Ombudsman Report

Review of Actions at Stauffer Chemical Company Superfund Site, Tarpon Springs, Florida

Report 2004-P-00018

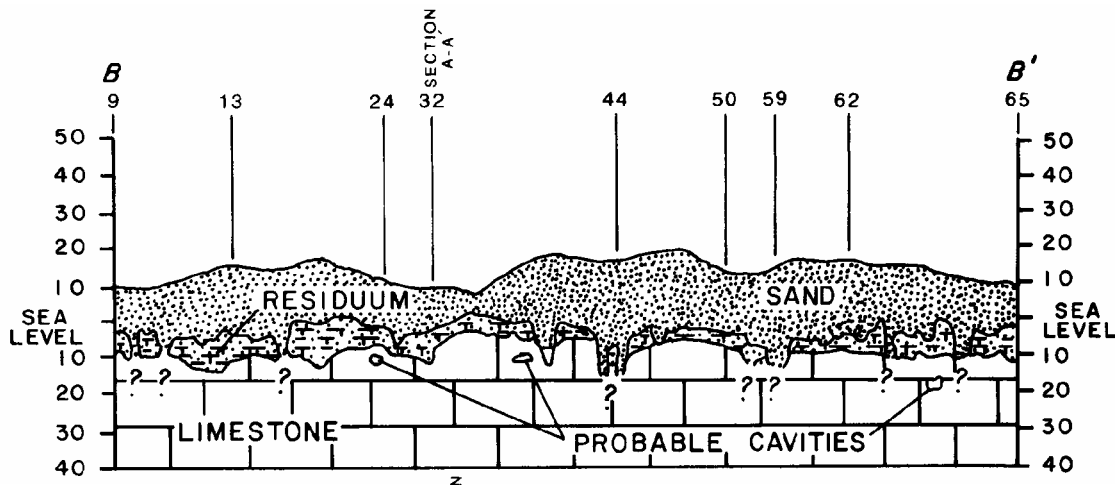
At the Stauffer site the occurrence of karst and the role of karst processes in the site hydrogeology was not mentioned in the Record until after completion of the Feasibility Study and issuance of the ROD (1998). The first reference to the karstic nature of the site appearing in the Record is Black & Veatch, 2000, which was written under contract to EPA.
